Memorandum

REGARDING Response to the Design Commission Comments dated 8/12/20
For the renovation project at 101 S. Marengo, Pasadena, CA 91101

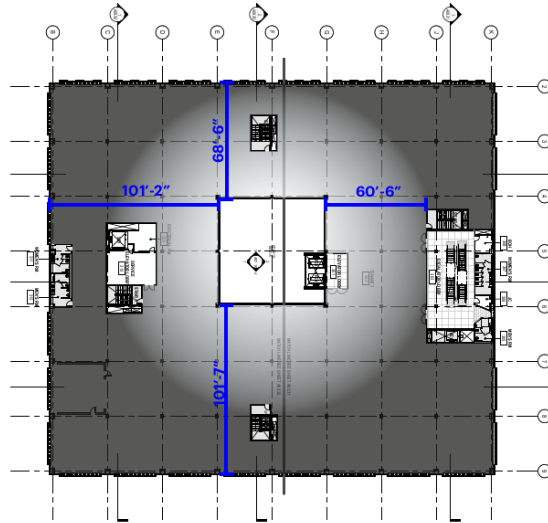
d. Retaining the windowless exterior and exploring other means of bringing natural light into the building including light shafts and light shelves, and

Our team analyzed the option to retain the existing windowless travertine facades, while introducing a courtyard at the scale that is structurally feasible. The lighting diagram included that it would be virtually impossible to bring natural light to the perimeter and corners of each floor plate. However, as noted above, maintaining the monolithic windowless areas on the north and south elevations do provide a sense of the building's original character and how that character integrates into the building's updated functionality.
